RED BARN MACHINE	
TITLE PULLER, CLUTCH IN RACE REMOVAL	
DWG NO. RBW6305G03351-3G	REV 3A
UNLESS OTHERWISE SPECIFIED DIMENSIONS ARE IN INCHES	
TOLERANCES ON: DECIMALS .XXX ± .005 .XX ± .01 .X ± .1	
FRACTIONS ± 1/32 ANGLES ± .5°	
UNLESS OTHERWISE SPECIFIED 1. BREAK ALL SHARP EDGES .015 x 45° PR .015 R 2. DIMENSIONAL LIMITS APPLY AFTER PLATING	
SCALE NTS	DATE 3-30-10
SHEET 1 of 1

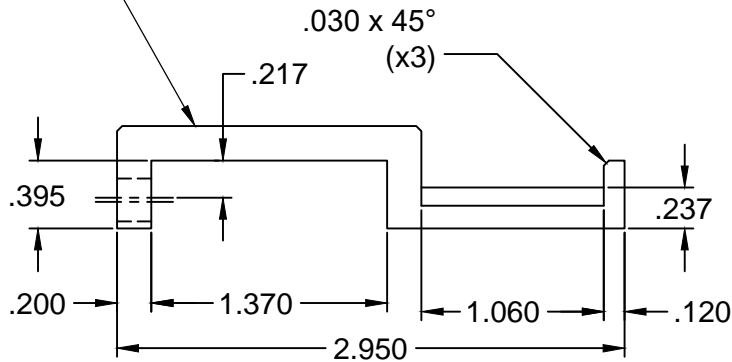
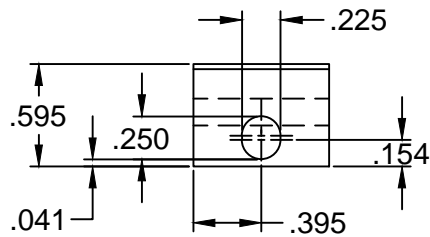
REVISIONS				
REV	DESCRIPTION	DATE	INITIAL	APPROVED
1	ADDED HEAT TREAT RC 35-40, ADDED MISSING DIMENSIONS, MATERIAL ROUND PER G.E.	1/19/11	RJC	RW
2	CH'D -1 BOM INFO PER GE, CH'D Ø2.166 TO Ø2.0 & Ø1.850 TO Ø1.687 PER S.E.	5/24/11	RJC	RW
3	CH'D DIA. FROM Ø1.687 TO Ø1.892 & Ø2.000 TO Ø1.578 AFTER INSPECTING ORIGINAL TOOL PER S.E. & D.W.	12/12/11	RJC	SE
3A	CORRECTED REV 3 DIA. CHANGE FROM Ø1.687 TO Ø1.578 & Ø2.000 TO Ø1.892 PER G.E.	3/1/12	RJC	GE
